PERMIT

SEWAGE DISPOSAL SYSTEM
HOWARD COUNTY HEALTH DEPARTMENT
BUREAU OF ENVIRONMENTAL HEALTH
410-313-2640

SUBDIVISION Dunfarmin Estates LOT NUMBER 1 ADDRESS 5400 Jamesway Court

LOCATION DRAWING

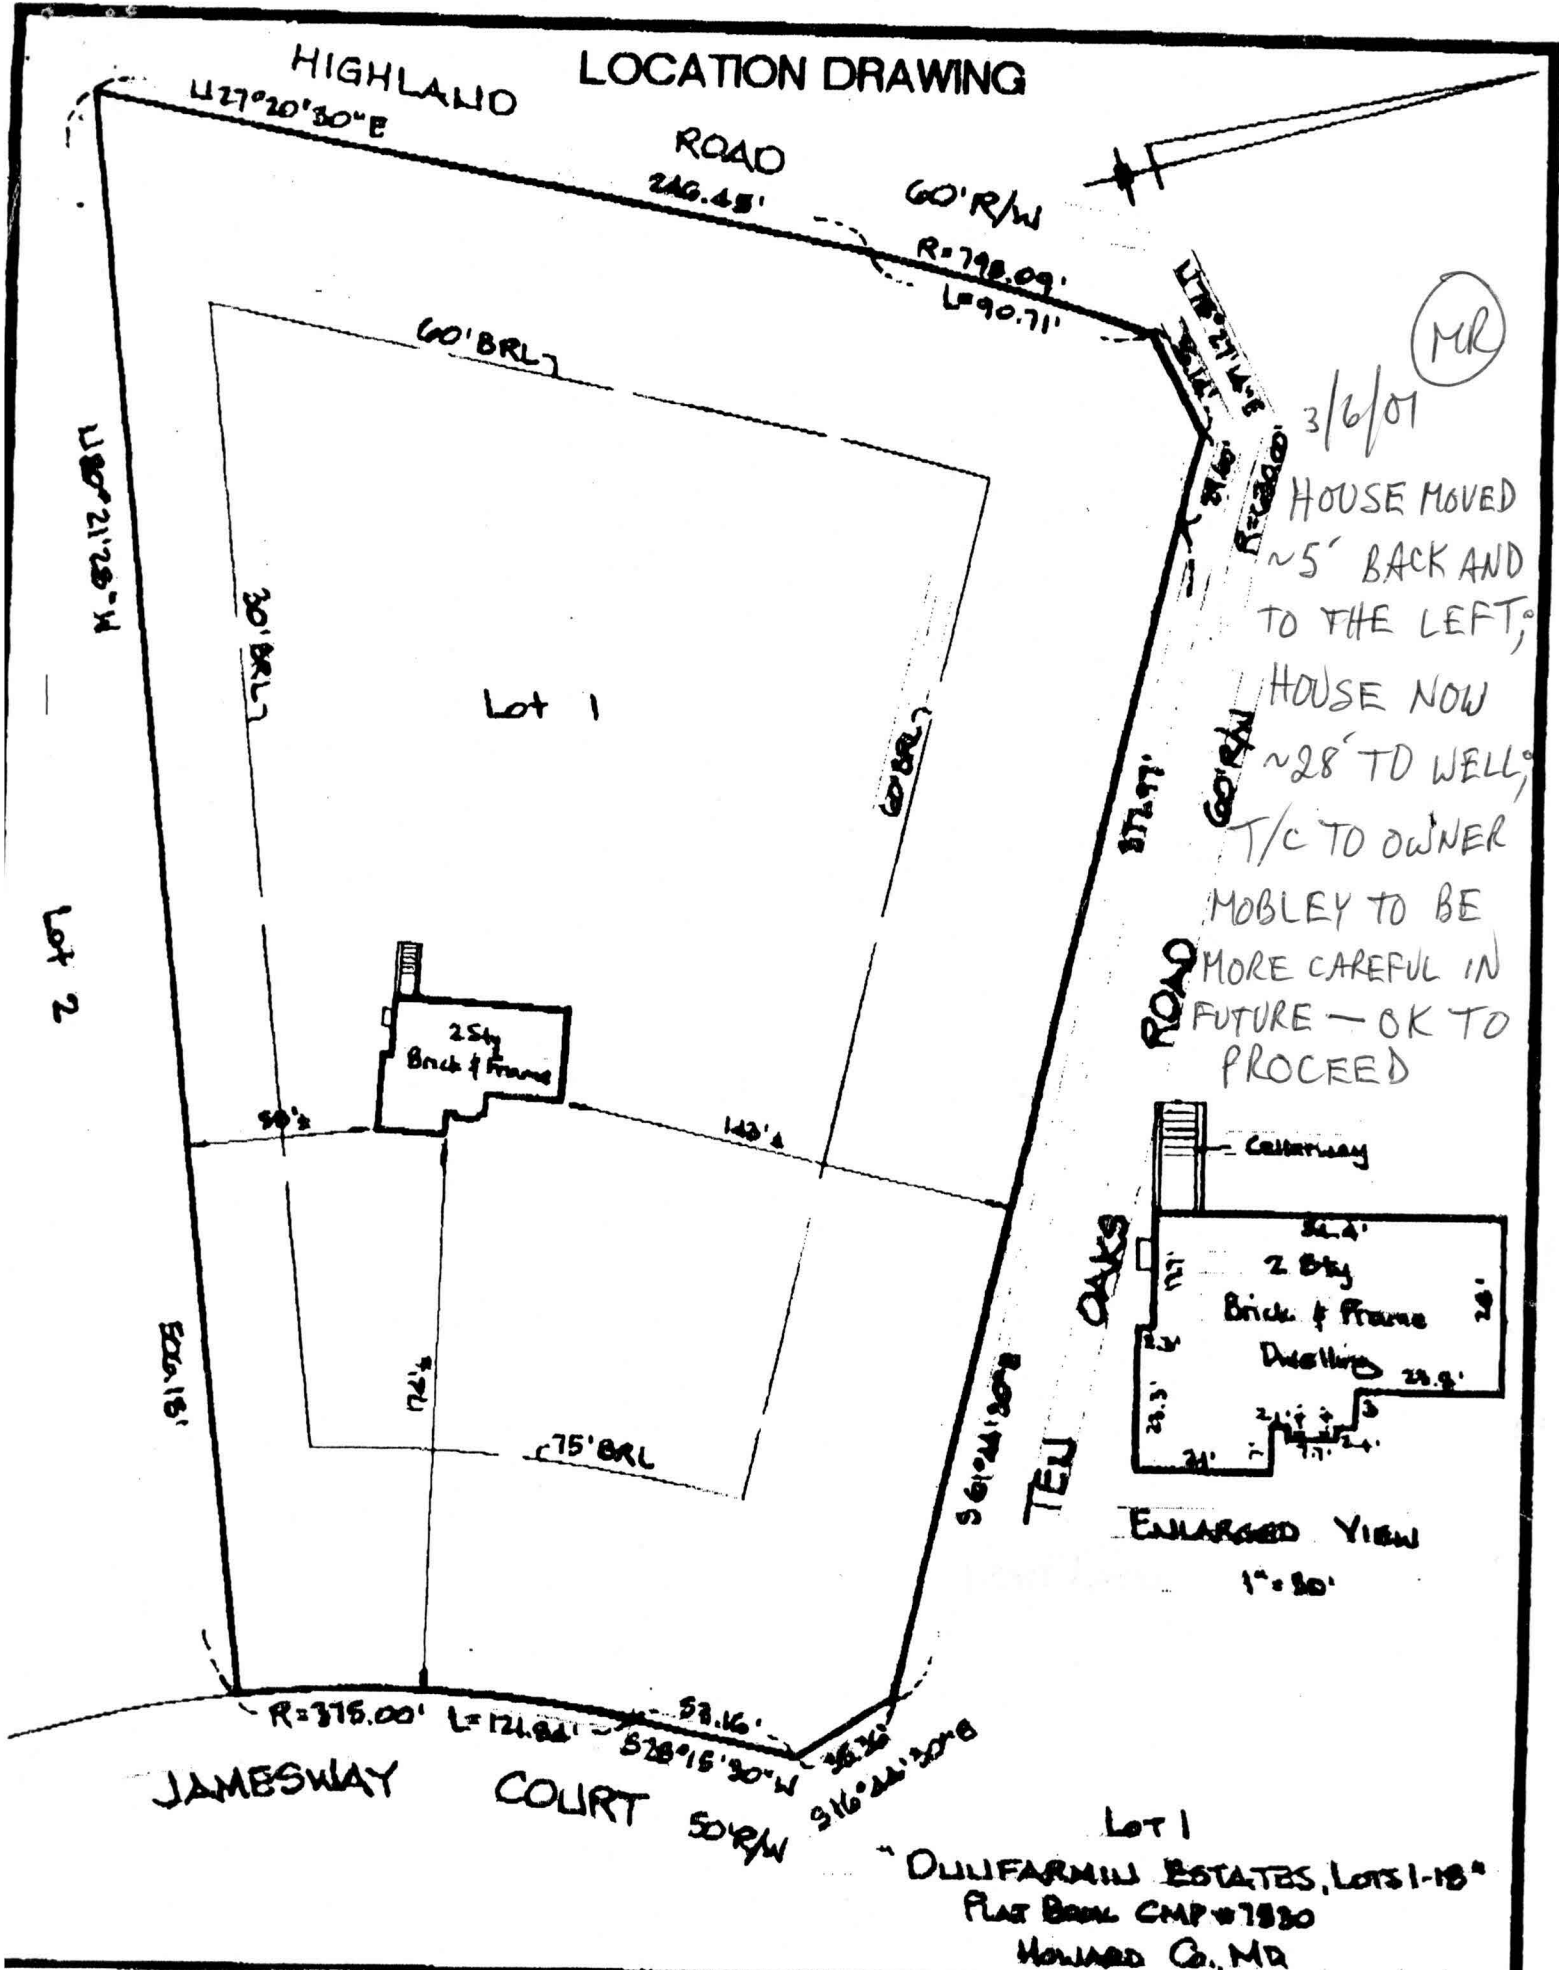
PRE-CONSTRUCTION INSPECTION: First Stakeout lines don't have enough future repair lines. OK to place DB.

INSPECTION COMMENTS: As spec'd but lot (Highland tract) closest S.T. (only 10 ft off S.T. as installed). The original perc test were 145 ft of permeability at 30' soil OK. R/P 4/3/01 (otherwise 1/2nd repair will be into driveway & driveway). Septic Tank set, OK to proceed. R/P 4/3/01

1st Trench installed & covered partially, 2nd trench partially dug OK to gravel when ready, OK to cover when finished leaving trench ends & Dist Box, septic tank for later inspection (House connection already made & covered). R/P 4/3/01
4/4/01- OK TO COVER ALL WORK, WPI - 2 PC CAP NEEDED (SRW)

ENLARGED VIEW
 1" = 30'

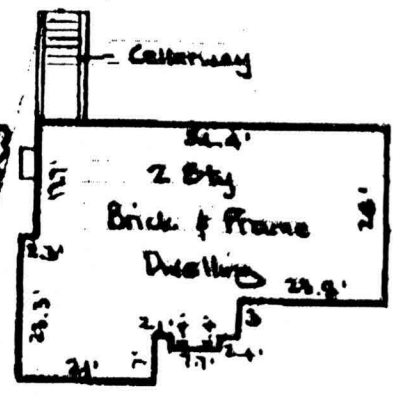
3/6/01
 HOUSE MOVED
 ~5' BACK AND
 TO THE LEFT;
 HOUSE NOW
 ~28' TO WELL;
 T/C TO OWNER
 MOBLEY TO BE
 MORE CAREFUL IN
 FUTURE - OK TO
 PROCEED
